ADDENDUM NUMBER 2

Re: North Brunswick High School HVAC
South Brunswick High School HVAC
West Brunswick High School HVAC
Brunswick County Schools
Proj. Number: PC21P0006

MDI Proj. No.: 213763

M102A

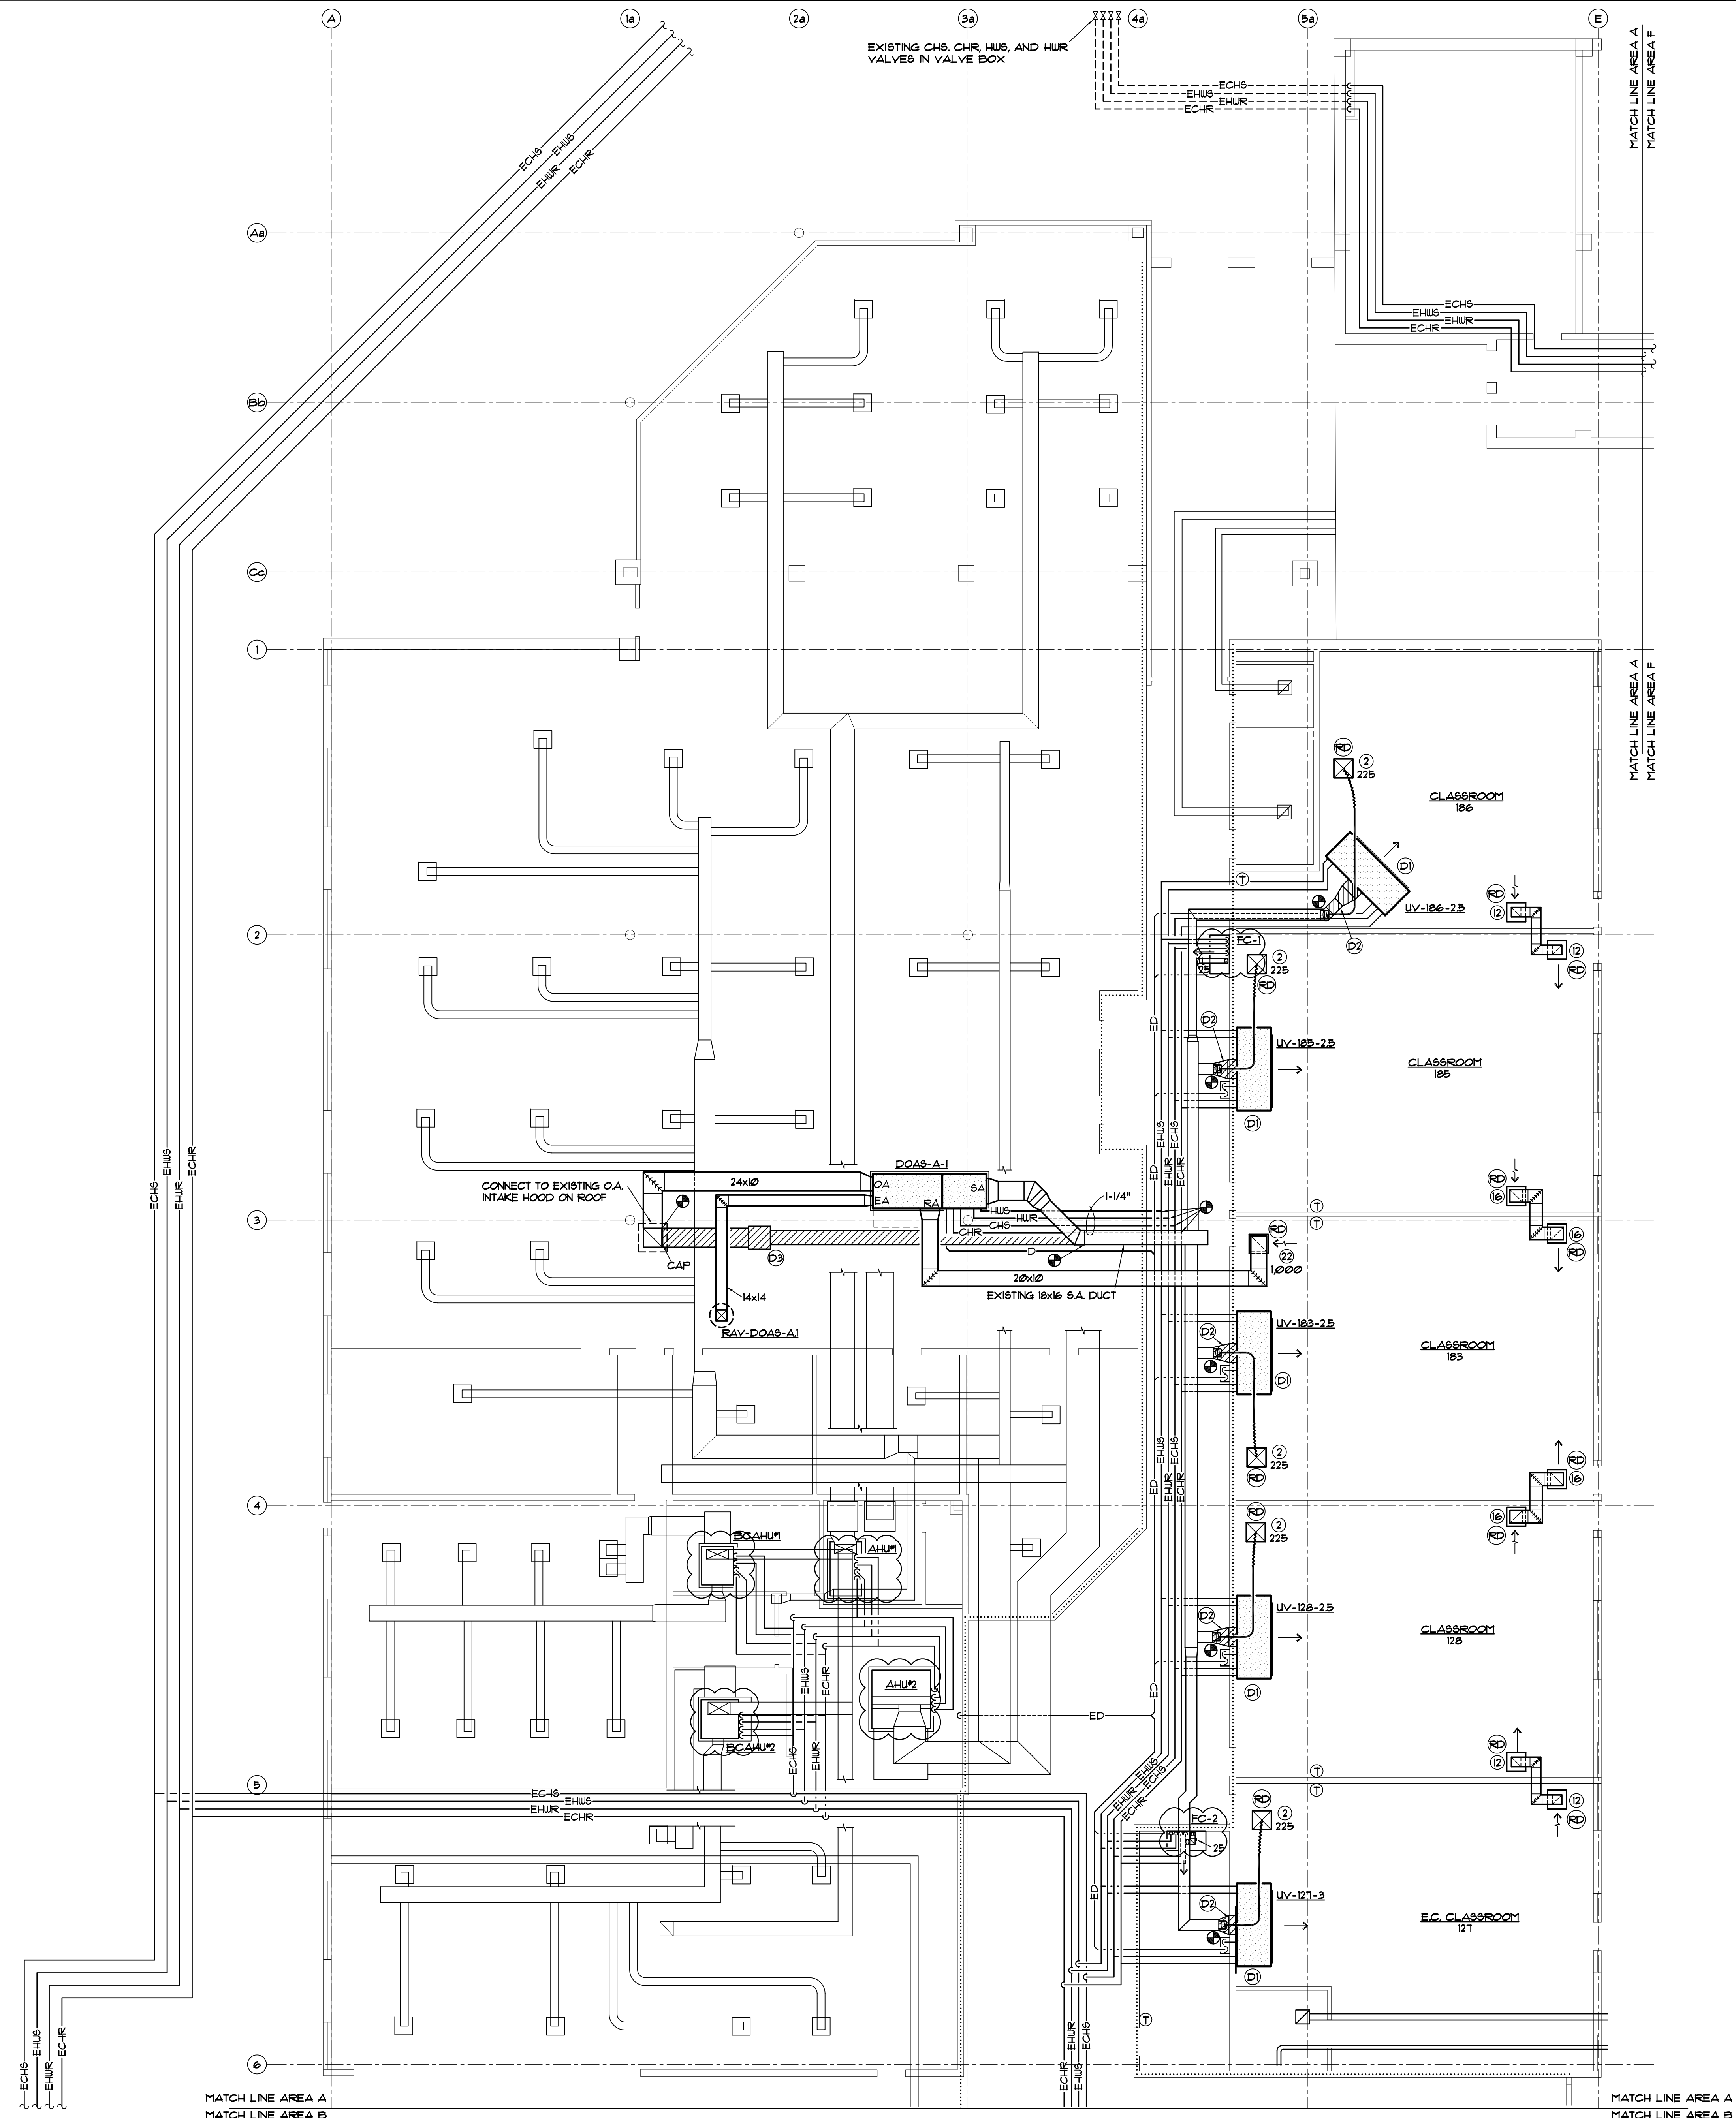
4. Refer to South Brunswick High School drawings M101A (Area "A") and M102A (Area "B"). Remove existing control valves complete, and replace with new control valves furnished by automatic temperature controls company as noted on the Control Valve Replacement Schedule on M001A. Applicable equipment on these (2) drawings are clouded.

M101A

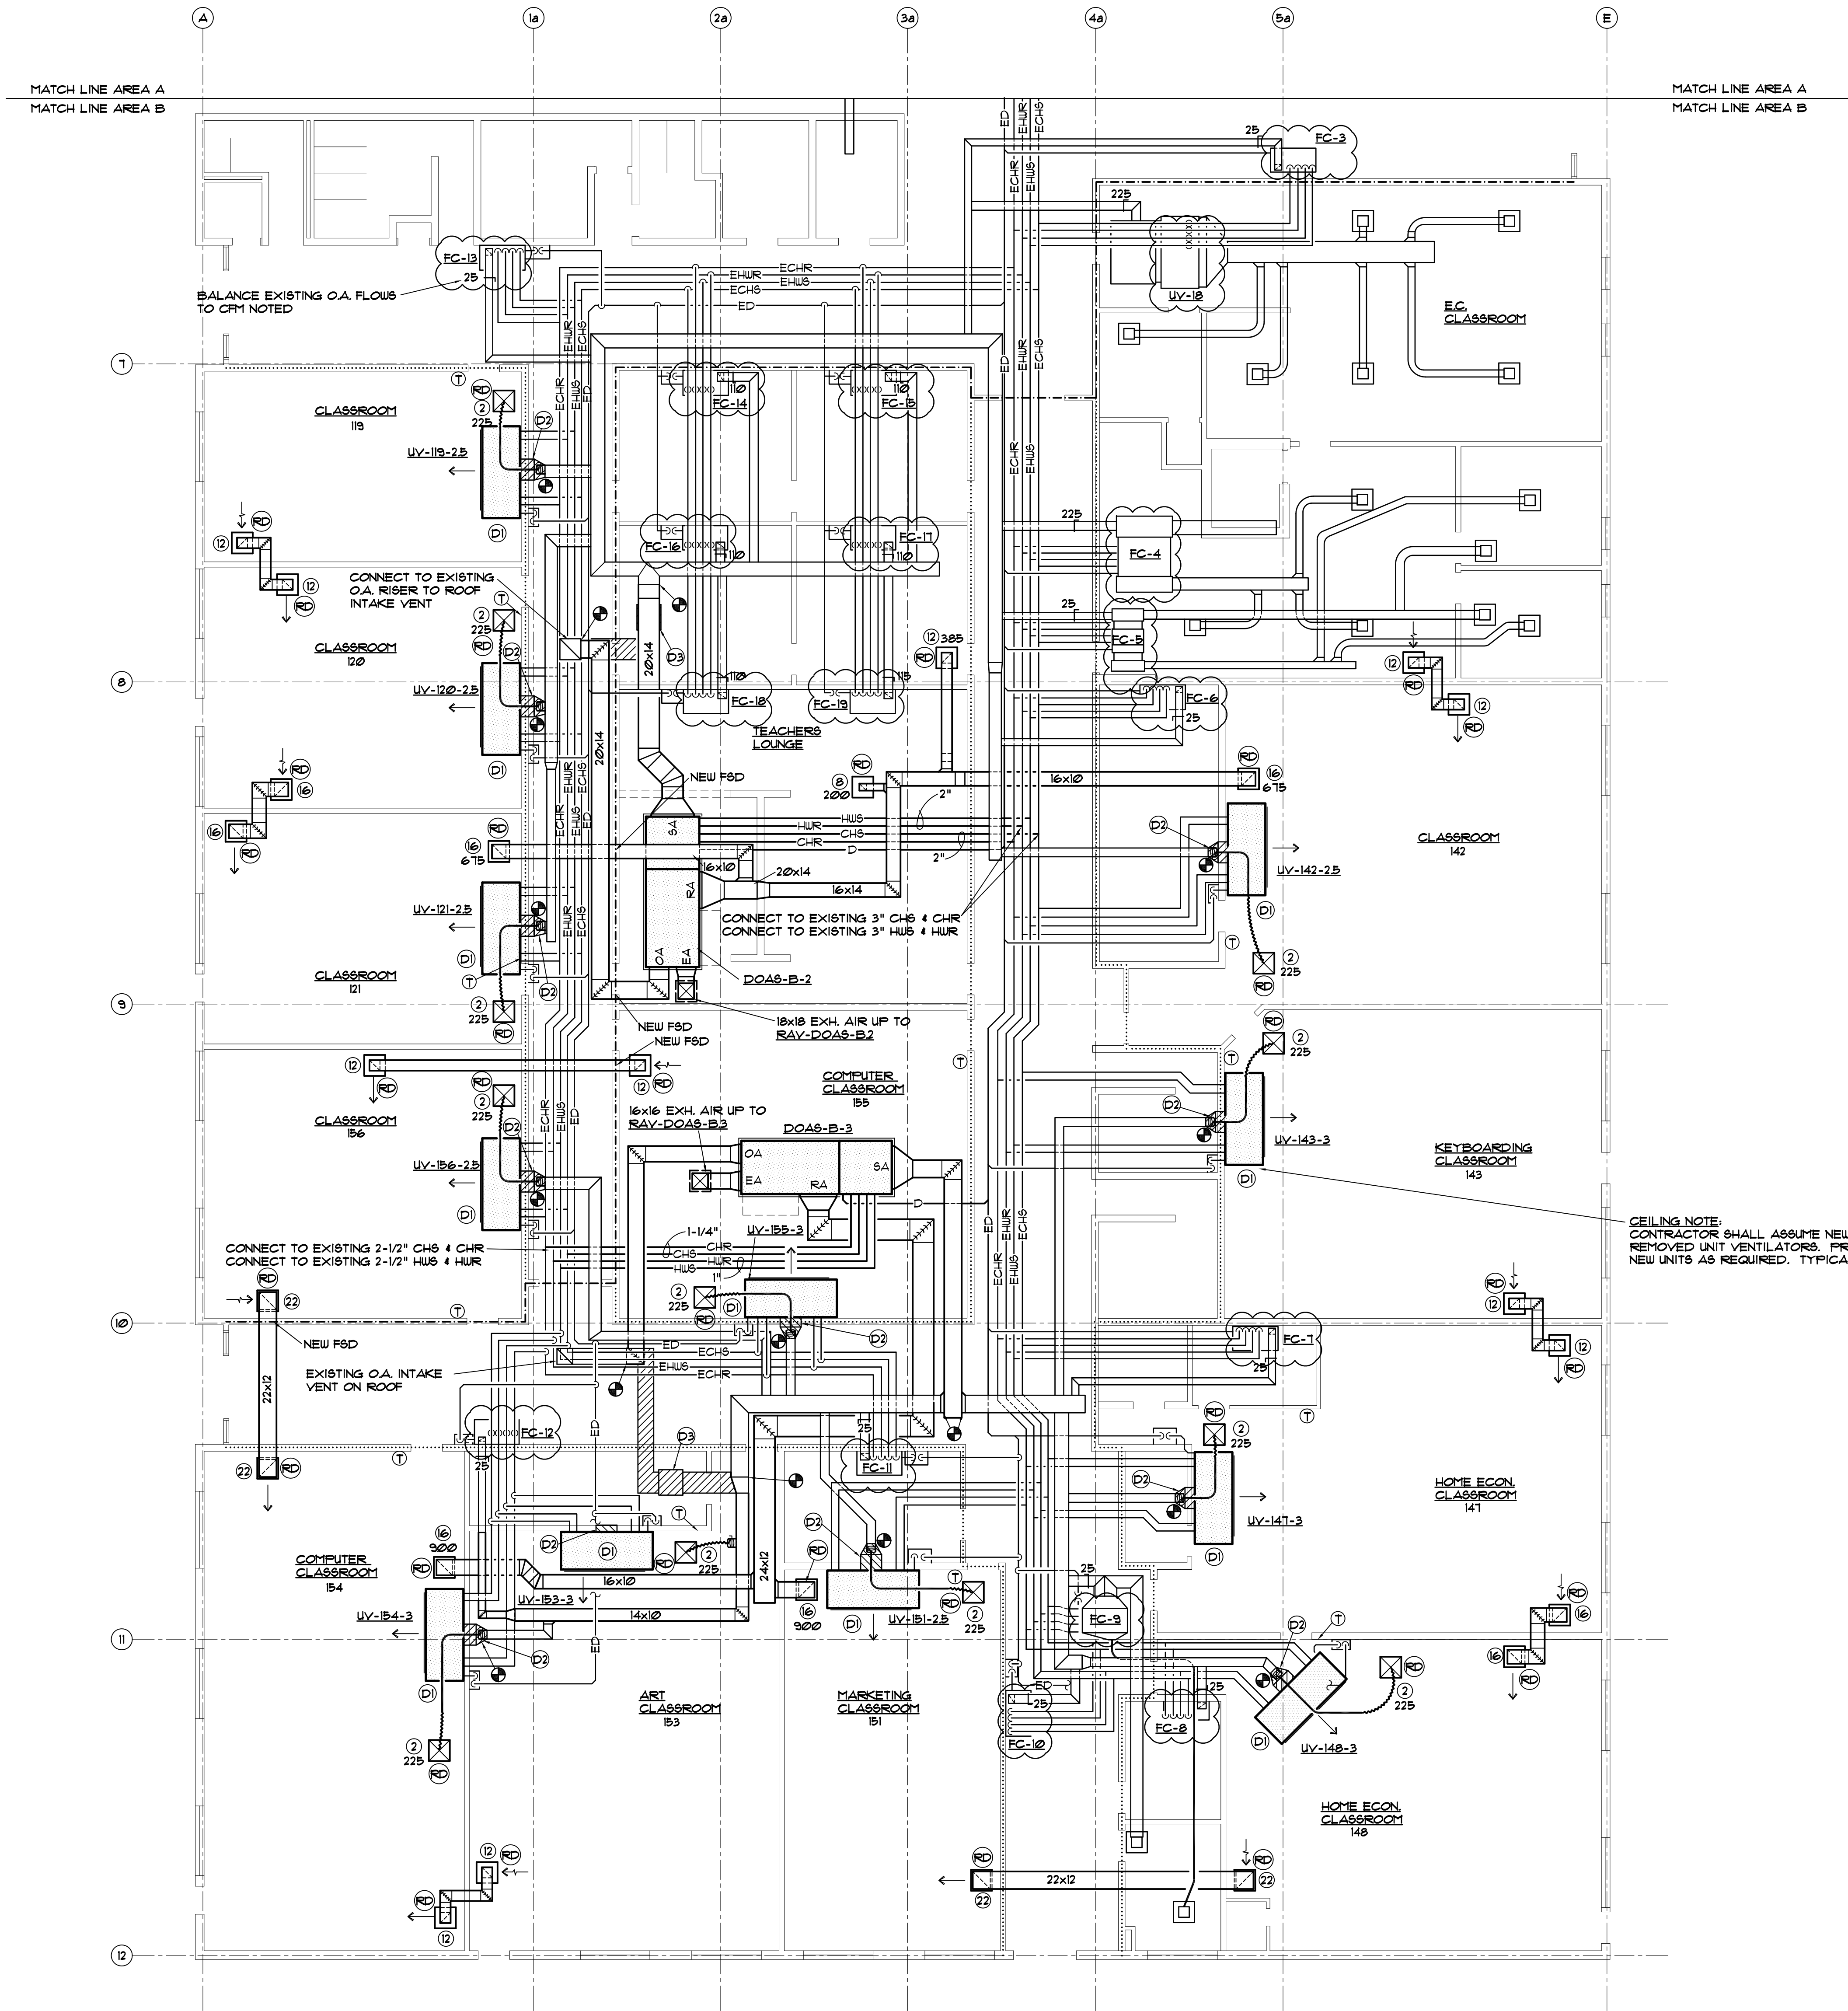
6. Refer to West Brunswick High School drawings M101A (Area "A"), M102A (Area "B") and M103A (Area "F"). Remove existing control valves complete, and replace with new control valves furnished by automatic temperature controls company as noted on the Control Valve Replacement Schedule on M001A. Applicable equipment on these (2) drawings are clouded.
